Project Name Ernie's Trailer☐ Combined Design Review☐ Detail Design ReviewMaster File # 18-5268Date: DRB MTG Date February 28, 2019

CITY OF OLYMPIA
BASIC COMMERCIAL DESIGN CRITERIA
Chapter 18.110

COMMERCIAL DESIGN REVIEW
FREEWAY CORRIDOR DISTRICT CHAPTER 18.145

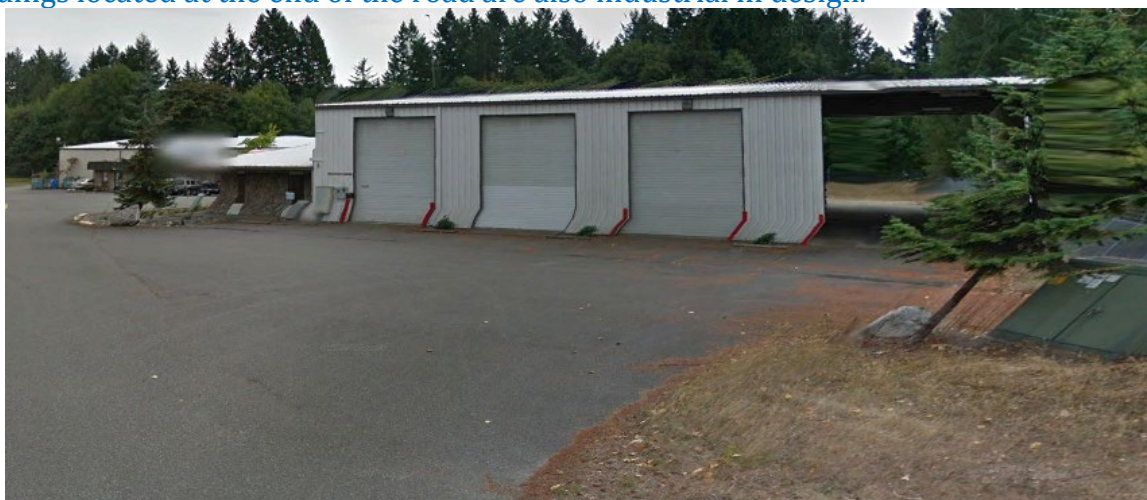
Staff Response: This is an area with industrial type uses and buildings. Staff feels the requirement is met. The Department of Transportation building has similar design, with multiple garage doors facing the street (see photo below).

Other buildings located at the end of the road are also industrial in design.
